Access Compliance Report

Public Rights-of-Way

(Curb Ramps)

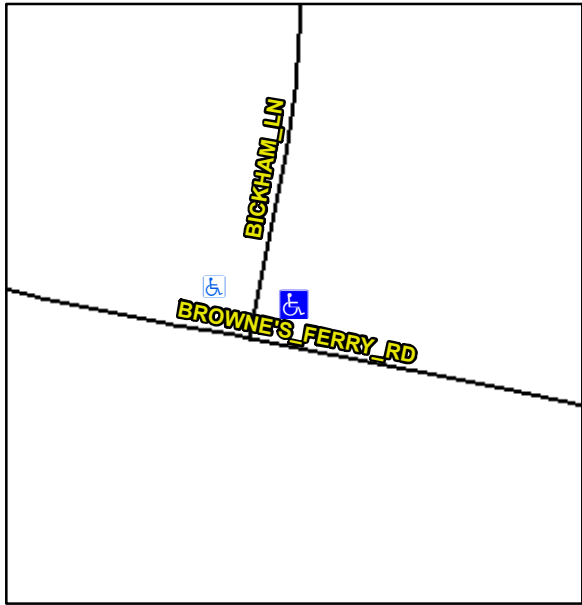
Intersection ID: 4049		Main Street: BICKHAM_LN		Cross Street: BROWNE'S_FERRY_RD		Location: NE											
ADA ID: 34C1BB11AB22		Ramp Type: Directional1		Initial Pass/Fail: Fail		Overall Compliance: No		Severity Score: 33.75									
Codes/Mitigation Info/Possible Solution				Field Measurements/Component Compliance													
<div></div> <div>Street 1 NameBICKHAM_LN</div> <div>Stop Condition-Street 1StopSign</div> <div>Street 2 NameN/A</div> <div>Stop Condition-Street 2N/A</div>				Possible Solutions:		Compliance		Description		Data		Compliance		Description		Data	
				Remove & Replace Entire Ramp.		N/A		Ramp Length (in)		47.0		N/A		Grade Break?		N/A	
				Surveyor Notes: N/A		No		Ramp Width (in)		47.0		N/A		Grade Break Slope (%)		0.0	
						Yes		Ramp Slope (%)		6.4		N/A		Grade Break XSlope (%)		0.0	
						No		Ramp XSlope (%)		7.2							
						N/A		Flare Type LT		N/A		N/A		Flare Type RT		N/A	
						N/A		Flare Slope LT (%)		N/A		N/A		Flare Slope RT (%)		0.0

N/A		Flare Traversable LT?		N/A		N/A		Flare Traversable RT?		N/A	
						N/A		Landing Length (in)		0.0		N/A		DWS Provided?		N/A	
						N/A		Landing Width (in)		0.0		N/A		DWS Contrast?		N/A	
						N/A		Landing Slope (%)		0.0		N/A		DWS Length (in)		N/A	
						N/A		Landing X Slope (%)		0.0		N/A		DWS Full Width?		N/A	
				PROW/ADA: R304.5.1, R304.5.3		N/A		Landing Curb? (Y/N)		N/A		N/A		DWS Offset LT (in)		N/A	
						N/A		Shared Landing?		N/A		N/A		DWS Offset RT (in)		N/A	
						N/A		Gutter Ponding?		0.0		N/A		Gutter Slope (%)		N/A	
						N/A		Gutter Lip Ht (in)		0.0		N/A		Gutter X Slope (%)		N/A	
						N/A		Painted X Walk1?		No				Road Slope (%)		6.6	
								X Walk 1 Direction		To W				Road X Slope (%)		1.9	
								X Walk 1 Width (in)		N/A				Clear Space?		N/A	
								X Walk 1 Slope (%)		6.6		N/A		Clear Space to XWalk (in)		N/A	
								X Walk 1 X Slope (%)		1.9		N/A		Storm Grate/Utility Hazard?		N/A

N/A		Ramp inside XWalk1?		N/A				Storm Grate/Utility Type			
				Total Cost: \$ 1600.00		N/A		Any Obstructions?		N/A						N/A	
								Obstruction Type				Yes		Surface Condition? (G/P)		Good	
										N/A		N/A		Curb Slope (%)		8.4
